**From:** Norton, Vince  
**Sent:** Thursday, May 01, 2008 1:32 PM  
**To:** Williams, Gary  
**Cc:** Vicars, Gerald  
**Subject:** FW: Trigger Model  
**Attachments:** image002.jpg; image001.jpg; 301757 Trigger Blank REV E.PDF

**From:** Goto, Gregory [mailto:ggoto1@parmatech.com]  
**Sent:** Tuesday, April 29, 2008 5:35 PM  
**To:** Vicars, Gerald  
**Subject:** Trigger Model

#### SECTION A-A

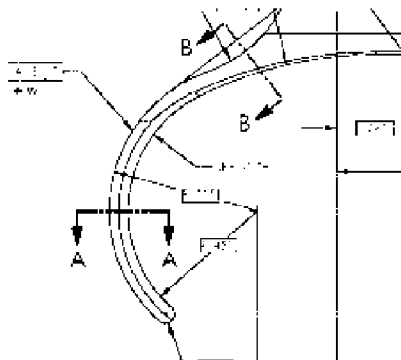
Gerald,  
Thanks for reviewing those items for us.  
Concerning the .515 and .451 radii, we were obtaining the correct dimension from the model however we were finding the Centerline of the radii offset from each other. On the 2-D, it looks like the centerlines are the same point. This would affect the design of our secondary op coin and the overlay which we use to inspect the part. By the way, will you be supplying overlays for the Profile callouts on the print?  
Regards,  
Greg

Gerald,  
 I ran into a problem with the Trigger model while designing the coin. It appears that the model doesn't match the 2-D print in the areas we checked. We plan to have the coin anvil mate with the part at the nominal dimension to insure the True Position in the finger pull area. The .300 radius on print is coming up about .050 larger on the model.

We are measuring the centerline for the .515 and .451 radii at a slightly different position on the model. Could you confirm with your CAD folks that we are measuring the model correctly?  
 If it turns out the 2-D and model are different, which one will we be asked to maintain the True Position / Profile for?  
 Regards,  
 Greg

The updated trigger blank drawing is attached to forward to Parmatech. This drawing should address all of their concerns over part and drawing discrepancies.

- 1) After discussing your concerns, design will update the 2-d drawing to reflect the .350 radius that is actually on the model.
- 2) Design has reviewed the radii (.515 & .451) and verified these dimensions. It may be in where you are taking your measurements that is giving you different data. We can discuss this at our Friday (5/2/08) conference call if you still have concerns.
- 3) The 2-d part drawing will be the final authority for piece part acceptance.
